Re: MM Docket No. 93-95 Windsor, CA

PETITION FOR LEAVE TO AMEND

Amendment No. 3  
Application of Judy Yep Hughes  
BPH-911115MT  
Windsor, CA

AMENDMENT TO PENDING APPLICATION (BPH-911115MR)  
FOR A CONSTRUCTION PERMIT FOR A  
NEW FM BROADCAST STATION

EXHIBIT 1  
VERTICAL PLAN SKETCH  
PROPOSED(FM) WINDSOR, CA

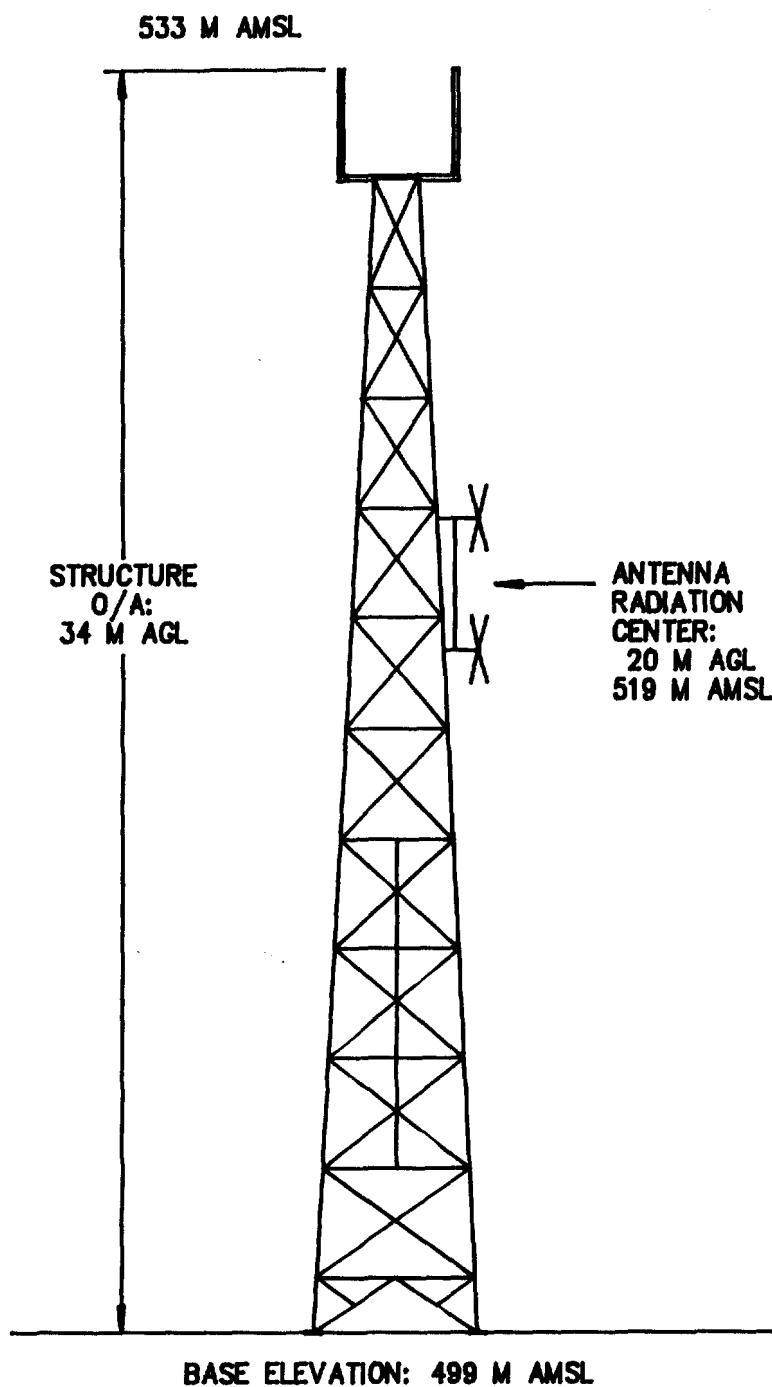
This Engineering Report supports an amendment to a pending application (BPH-911115MR) for a new FM broadcast station on Channel 281A at Windsor, California. The amendment is filed in response to the requirements of the Hearing Designation Order in MM Docket No. 93-95, which requested that the applicant correct the site elevation shown in the original application from 488 meters AMSL to 499 meters AMSL. The corrected figure is based on a detailed survey map submitted by the opposing applicant in the proceeding in MM Docket No. 93-95.

Operation is proposed on Channel 281A (104.1 MHz) with an effective radiated power of 0.25 kilowatts (-6.02 dBK) and an antenna height above average terrain of 348 meters. The proposed effective radiated power produces a distance to the 60 dBu F(50,50) contour of 24.2 kilometers, which rounds to 24 kilometers when taken to the nearest meter. This is the maximum ERP allowed for an "old" Class A station under the requirements of §73.213 of the Commission's Rules.
